Request for Change Order

Project Name: HWY 320 (329 to I75)

RCO No.: 02

Request for Change Order Description

#2
.05
.42

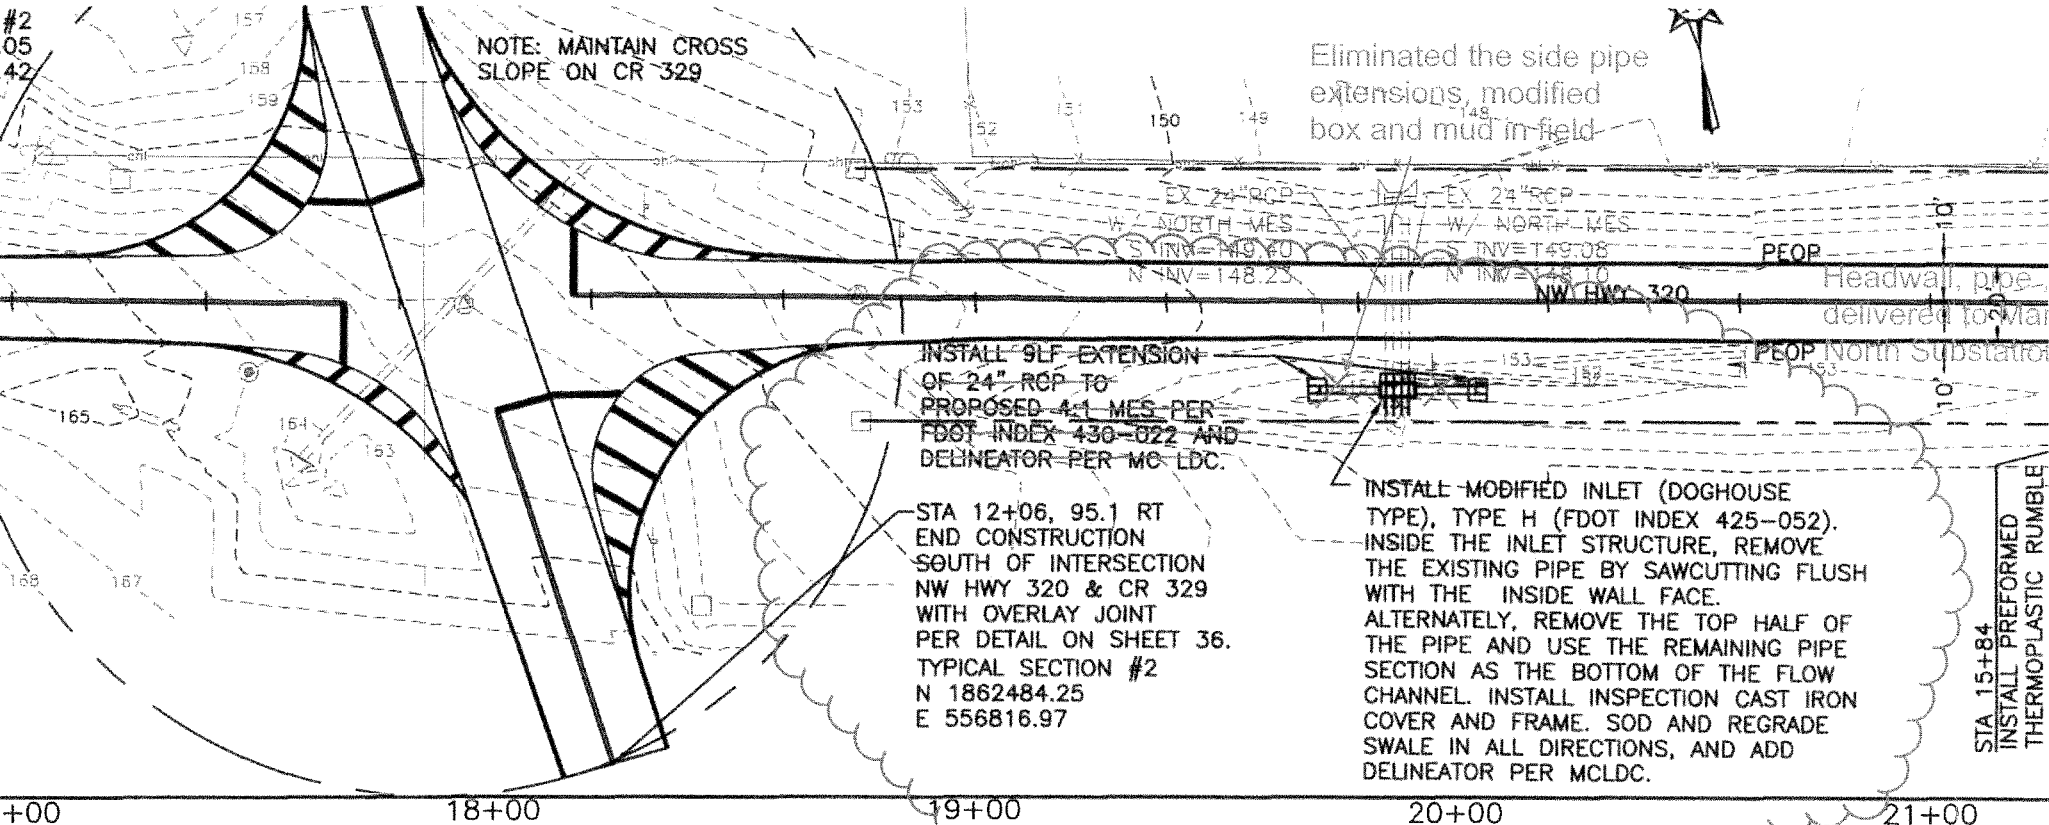
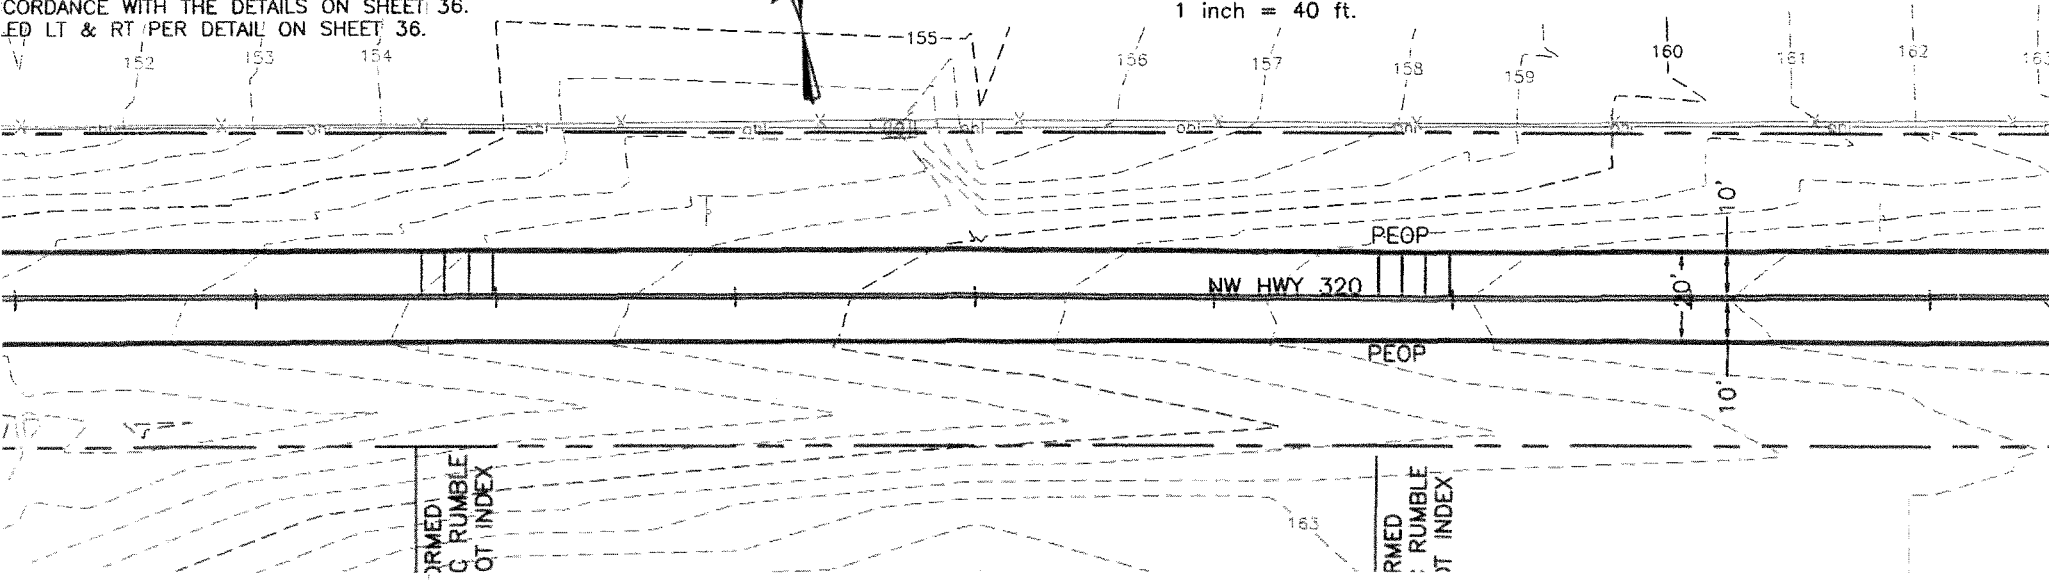
Due to field modifications in the field at the following station, this change order is to capture the asbuilts with no additional cost.

Station 14+00

Right Side

1. Eliminated two side pipes, modified the the box and mud work.
2. Delivery of headwall, pipe, MES to Marion County North Substation.

Eliminated the side pipe
extensions, modified
box and mud in field
